2004 - 2009 Cadillac XLR: Service Bulletin: #15643A: Special Coverage - Airbag Light On - (Feb 2, 2017)

Subject:	15643A — Special Coverage Adjustment – Airbag Light On
Models:	2004 - 2009 Cadillac XLR
	2005 - 2013 Chevrolet Corvette

This bulletin has been revised to add accessory wiring harness part numbers to the Part Information section, update quantities of other parts required, and amend the Service Procedure to install the accessory wiring harness components. Please discard all copies of bulletin 15643.

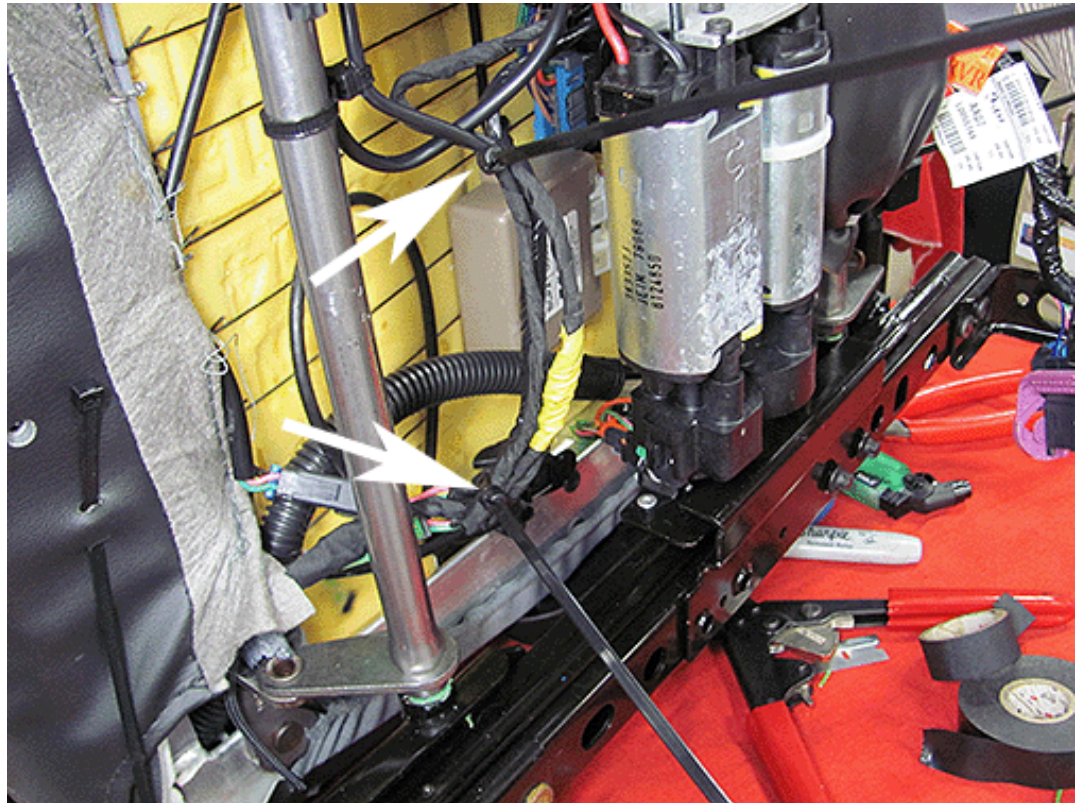
1. Route the harness to the front of the seat as shown.

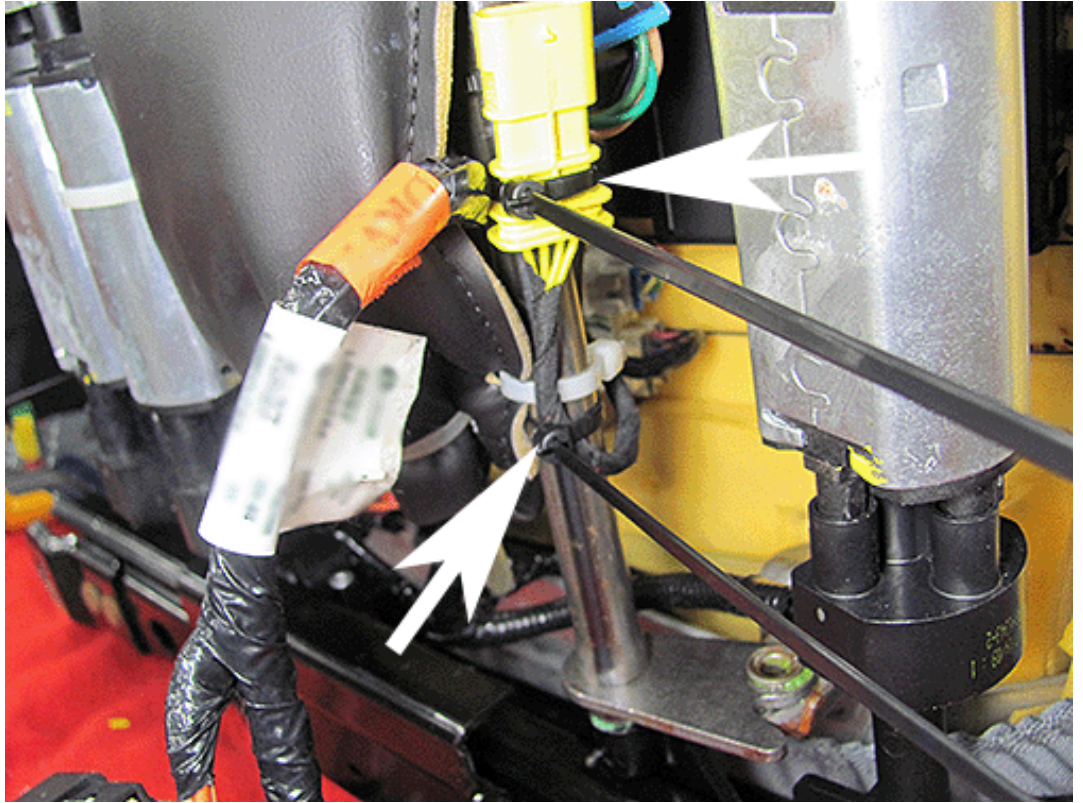
2. Secure the harness to the rear of the seat as shown.

3. Secure the wire connector and harness to the FRONT seat cross bar using two cable ties.

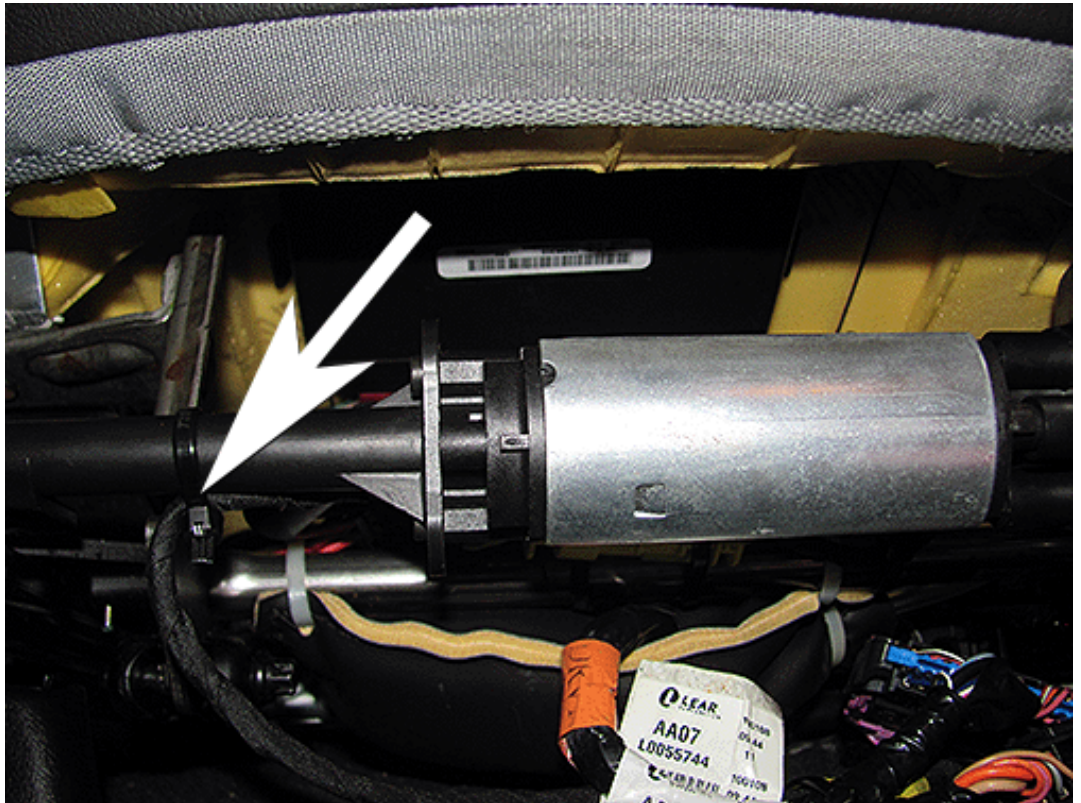
4. On the vehicle harness, pull the harness from under the carpet, to the front location as shown.

5. Measure 300mm (11.8 in) from the connector as shown.
6. Cut the four body side wires.
7. Strip off approximately 13 mm (1/2 in) of insulation from the wiring ends. Fold the wires.
8. Add one approximate 38 mm (1.5 in) section of heat shrink tube to each of the four wires.
9. On the service connector, strip off approximately 13 mm (1/2 in) of insulation from the wiring ends. Fold the wires.
10. Join the four wires in the order documented above.
11. Crimp a splice clip over the joined wires using Special Tool J-38125-8, nest F. Verify the crimp quality. Repeat this crimp process on all four wire connections.
12. Solder all four crimp and splice clips using the Ultratorch, part number J-38125-5, or another butane fueled soldering iron.
13. Center the heat shrink tube over all four splices and shrink/seal the heat shrink tube securely over the splice crimp and insulated wires.
